TITLE OF PROJECT: Bessey Hall – Chiller Replacement

PROJECT NUMBER: CP23031

ADDENDUM NO: 03

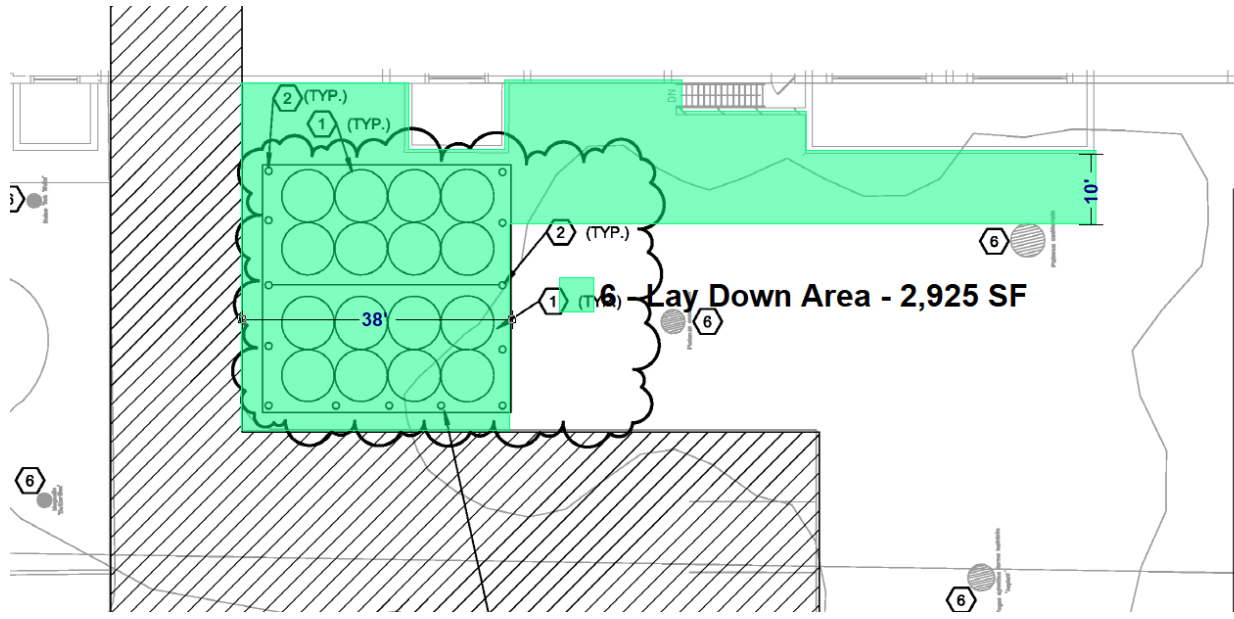
<u>ITEM NO.</u>	<u>DESCRIPTION</u>
1	Refer to specification sections 230700-HVAC Insulation and 232113-Hydronic Piping for buried chilled water piping material, insulation and jacketing requirements.
2	Refer to E2.03 for disconnection of existing lightning protection and reconnection at new cooling tower.
3	Refer to M5.01 for revised cooling tower schedule notes in reference to VFD/control panel location/enclosure and clarification regarding hours by cooling tower manufacturer.
4	Refer to M6.01 for Energy and Flow Meter locations and acceptable model numbers.
5	Assume 600 gallons of lithium bromide solution need to be disposed of. Include a \$10,000 dollar allowance for trucking and landfill disposal costs.
6	MSU Landscape services will handle all tree protection, construction site fencing, install asphalt millings/stone, and final site restoration. Below is a sketch on the extent of laydown area. They will handle tree trimming above the areaway and adjacent to the building along with cleaning out the areaway of debris. See sketch below.

M6.01

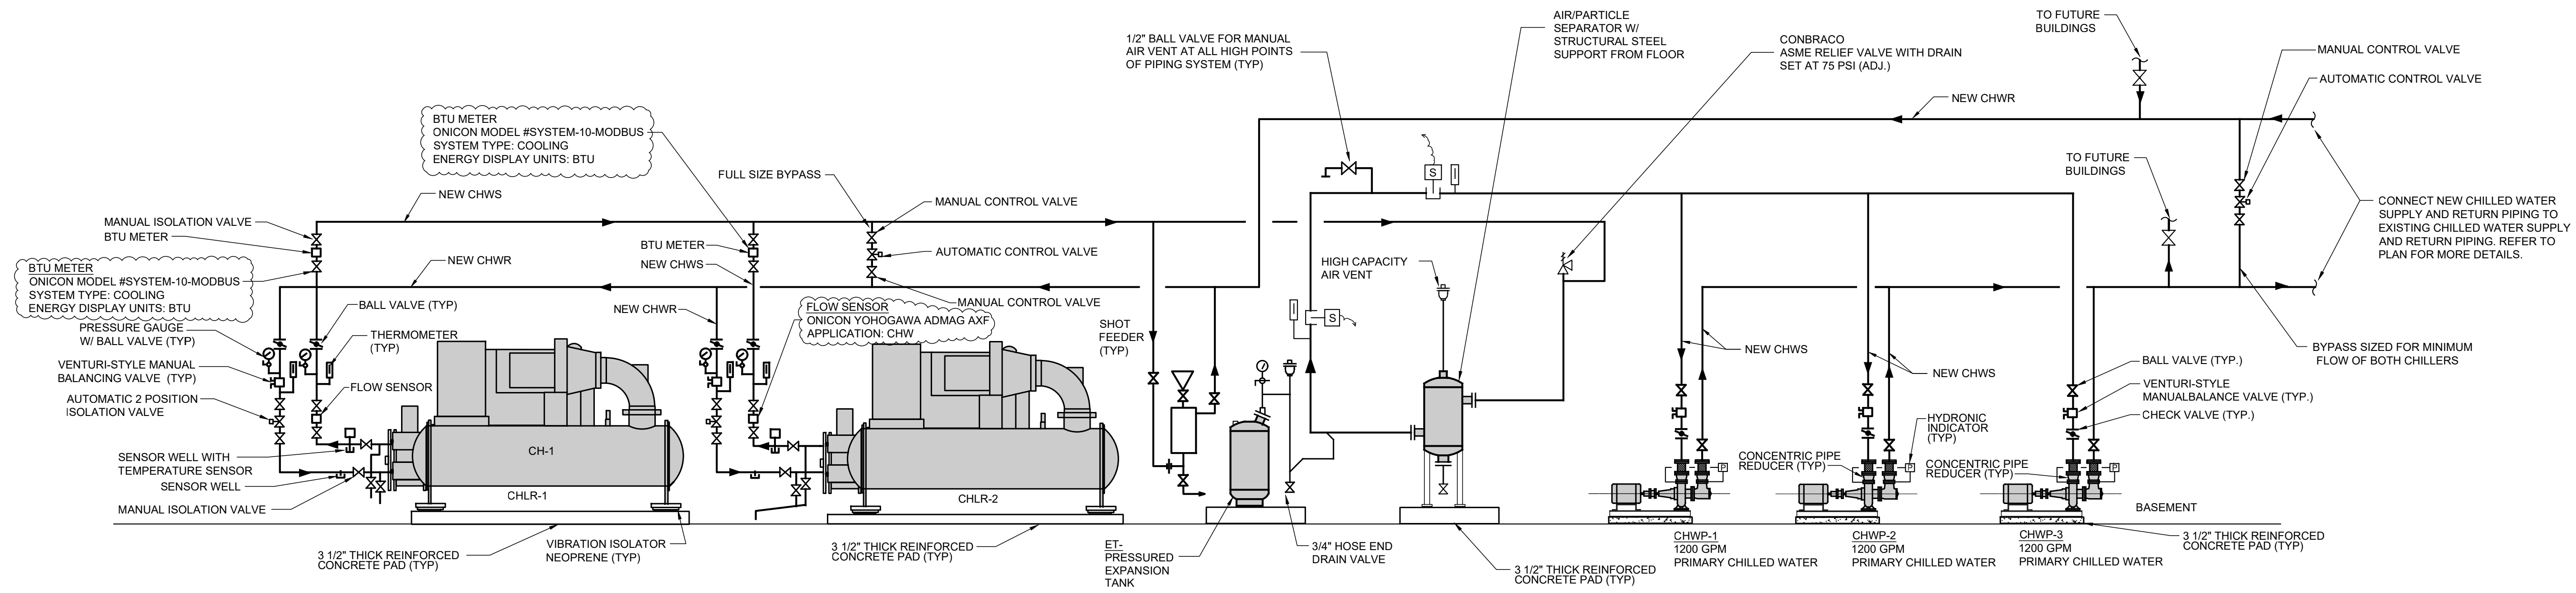
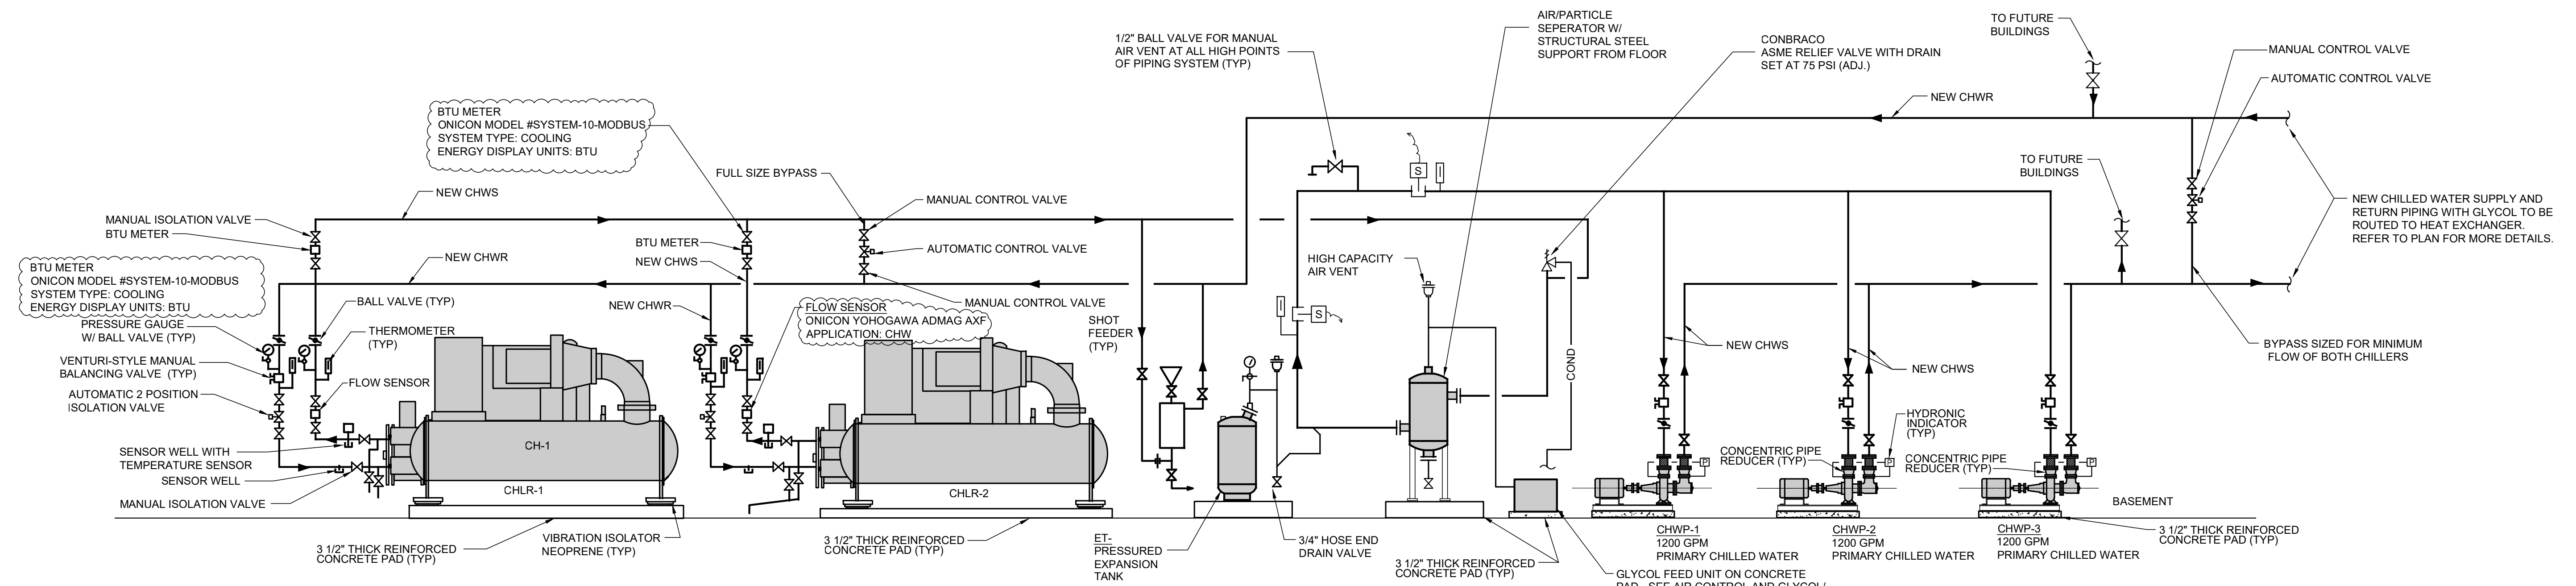
CHILLED WATER SYSTEM DIAGRAM
 NO SCALE

CHILLED WATER SYSTEM DIAGRAM ALTERNATE #1
